CLIENT	CITY OF RICHMOND
BUILDING	RICHMOND MUNICIPAL AIRPORT
PROJECT	NEW TERMINAL BUILDING
LWC PROJECT NO.	25106.00
ADDENDUM NO.	03

DATE: | **2026-04-13**

Addendum 003 RFI Log

Project Name: Richmond Municipal Airport - New Terminal Building

SITE UTILITY PLAN

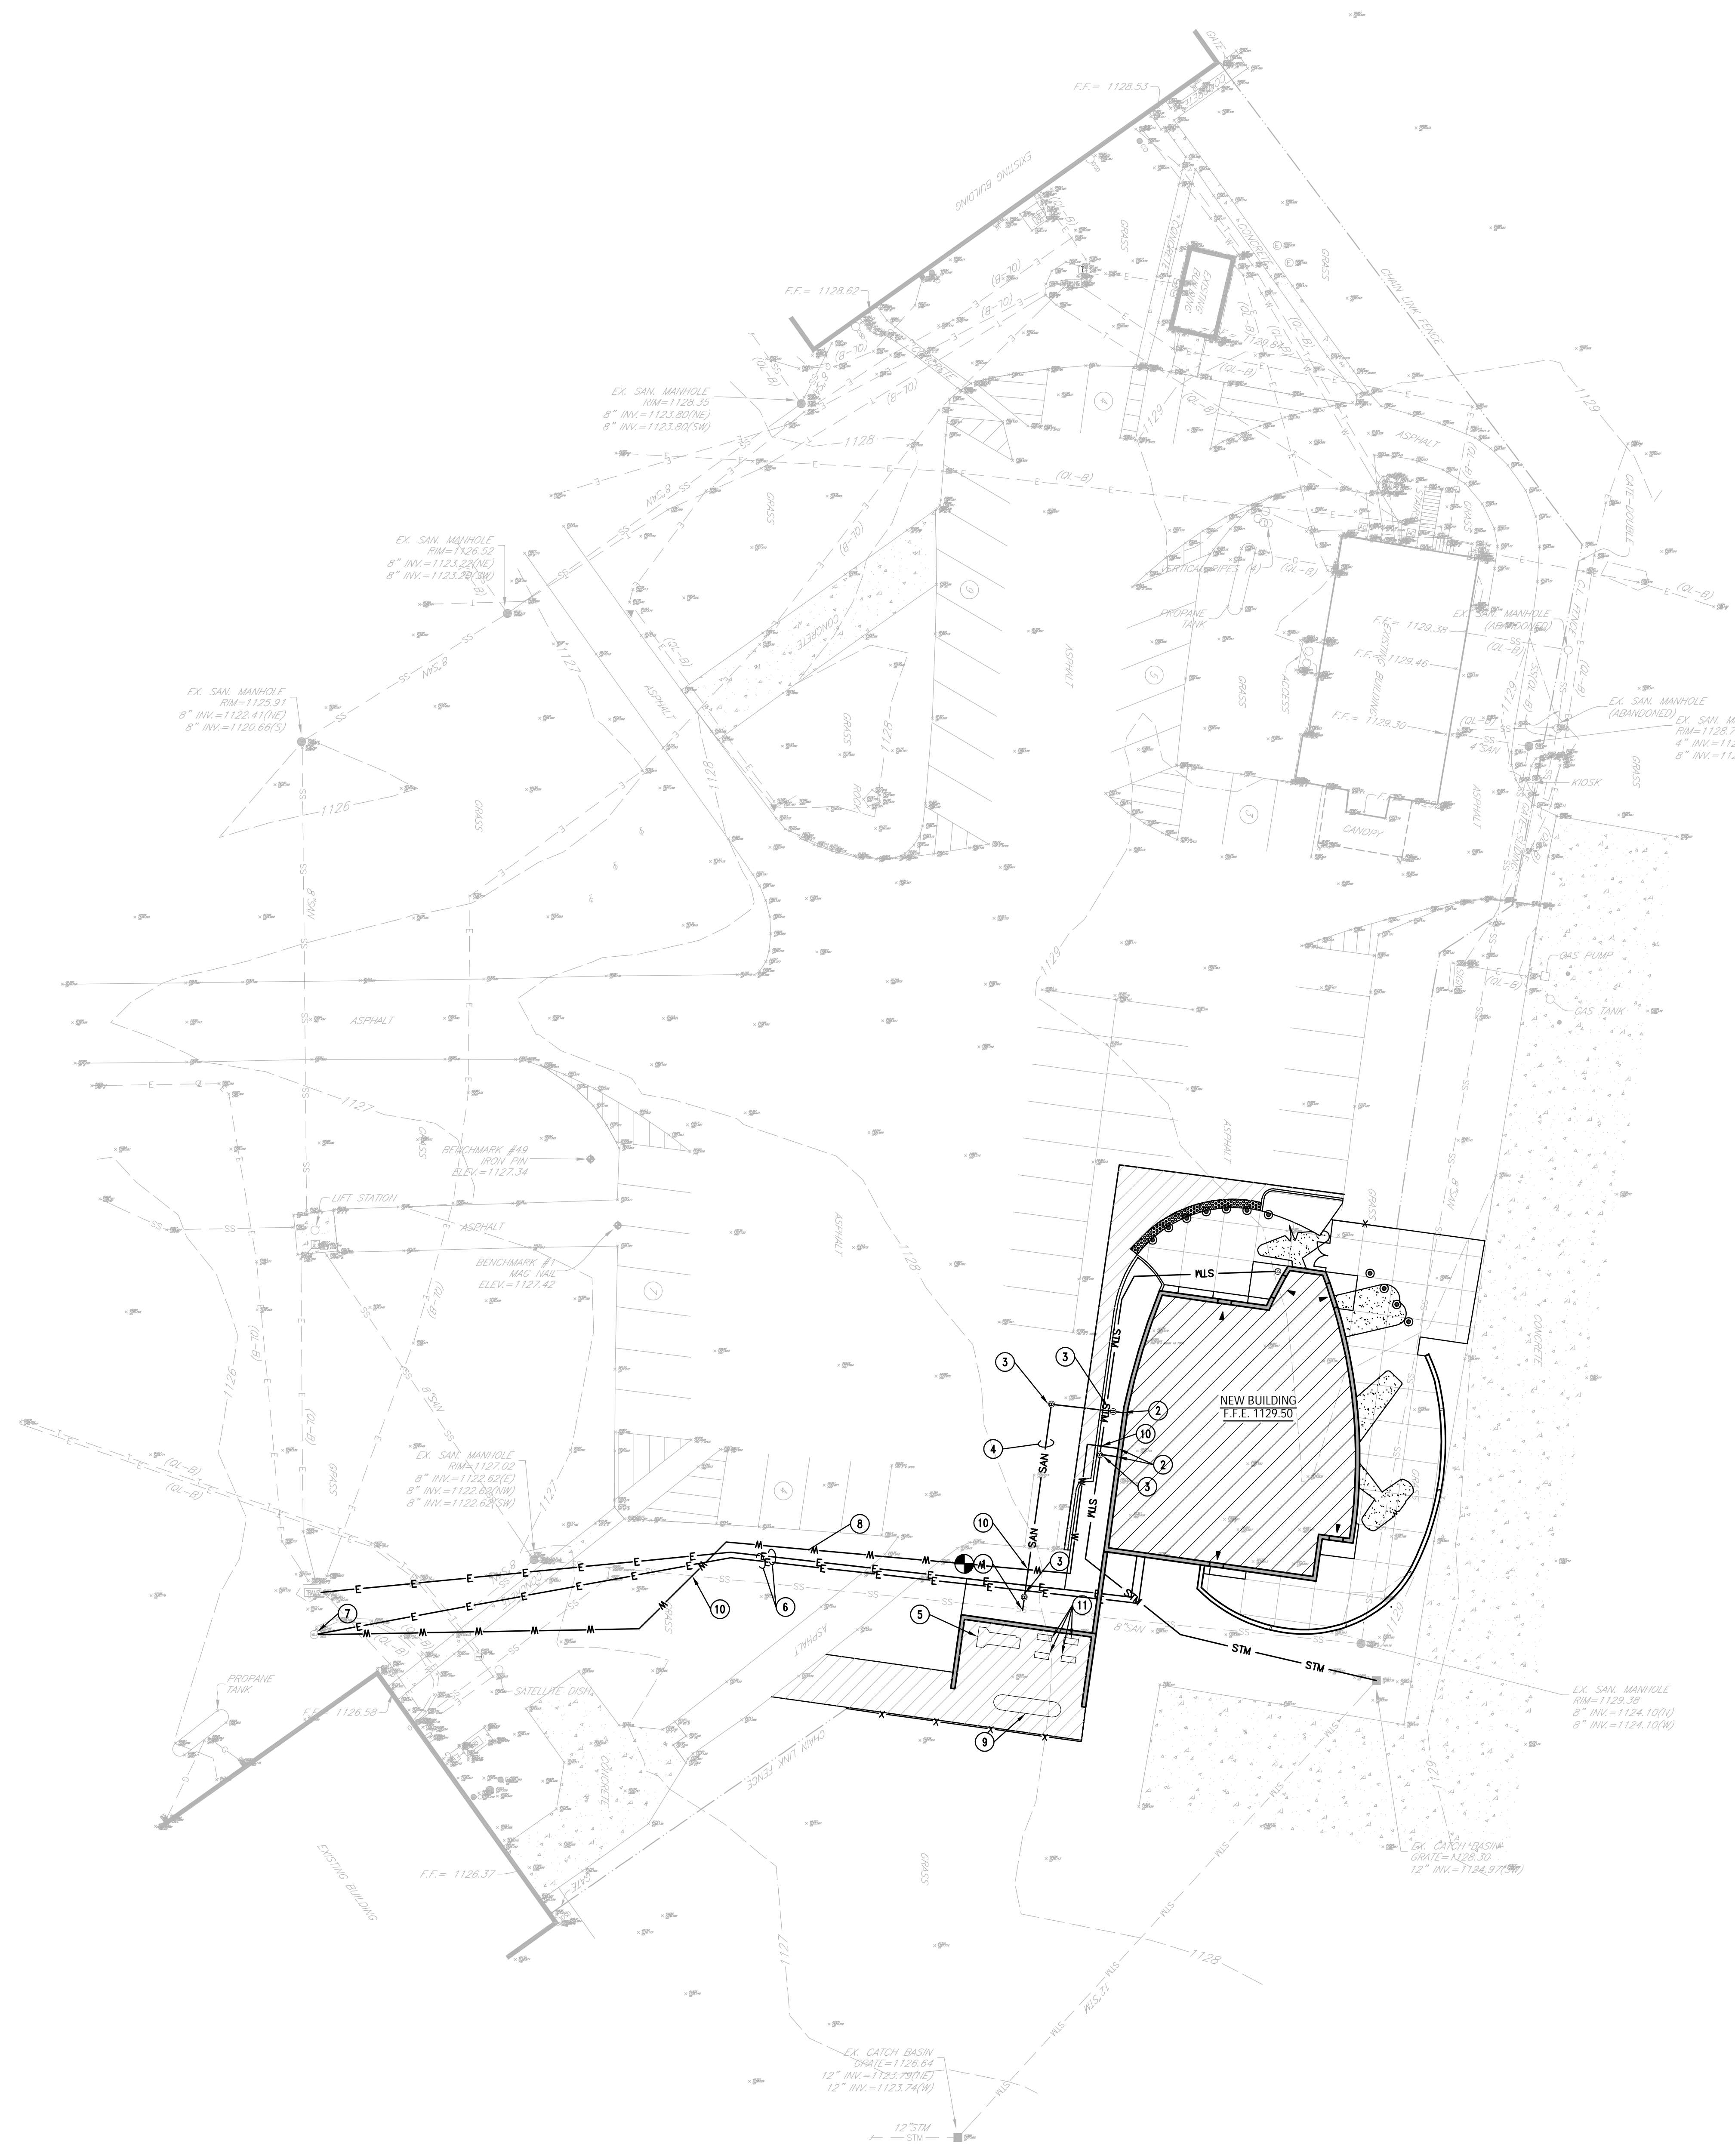
GENERAL ITEMS ALL	RFI Questions & Responses
SPECIFICATIONS	SECTION – 000400 – BID PROPOSAL FORM - UPDATED FORM TO INCLUDE ALTERNATES 5 & 6 SECTION – 012300 – ALTERNATES - UPDATE ADDING ALTERNATES 5 & 6
DRAWINGS	C400 SITE UTILITY PLAN - SANITARY LINE CHANGED FROM A 4” TO A 6” PIPE C510 SITE IMPROVEMENT DETAILS - UPDATED DETAIL 2/C510 TO REFLECT THE 6” CONCRETE PAVEMENT - DELETED DETAILS 10 & 11/C510

3. NEW EXTERIOR CLEANOUT.
 4. 84LF OF 6" PVC SANITARY PIPE @ 1.04%.
 5. NEW PROPANE GENERATOR BY OWNER. SEE ALTERNATES.
 6. NEW ELECTRICAL LINE.
 7. REFER TO WELL DRILLERS PLANS FOR EXISTING WELL CONNECTION AND DETAILS.
